# **Pentium® Processor Specification Update**

Release Date: December 1997

Order Number 242480-033

The Pentium® processor may contain design defects or errors known as errata which may cause the product to deviate from published specifications. Current characterized errata are documented in this Specification Update.

Figure14-1. Maximum Undershoot Level, Undershoot Threshold Level, and Undershoot Threshold Duration

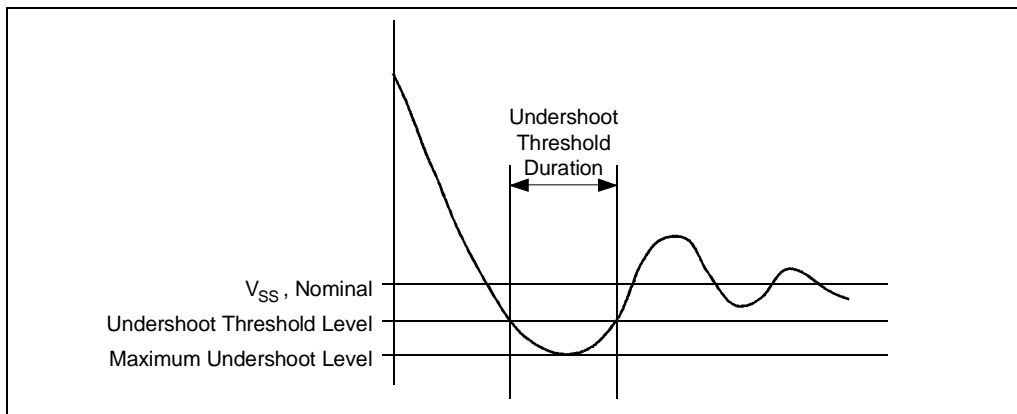
**MAXIMUM RINGBACK SPECIFICATION:** The maximum ringback of CLK associated with its low state (undershoot) must not exceed 0.8V as shown in Figure 14-1.

**MAXIMUM UNDERSHOOT AND MAXIMUM RINGBACK SPECIFICATIONS:** The display should show continuous sampling (e.g., infinite persistence) of the waveform at 500 mV/div and 5 ns/div (for CLK) for a recommended duration of approximately five seconds. Adjust the vertical position to measure the maximum undershoot and associated ringback. There is no allowance for crossing the maximum undershoot or maximum ringback specifications.

**UNDERSHOOT THRESHOLD DURATION SPECIFICATION:** A snapshot of the clock signal should be taken at 500 mV/div and 500 pS/div (for CLK). Adjust the vertical position and horizontal offset position to view the threshold duration. The undershoot threshold duration is defined as the sum of all time during which the clock signal is below -0.5V within a single clock period. The undershoot threshold duration must not exceed 20% of the period.

This undershoot specifications are illustrated graphically in Figure 14-1 and Figure 14-2.
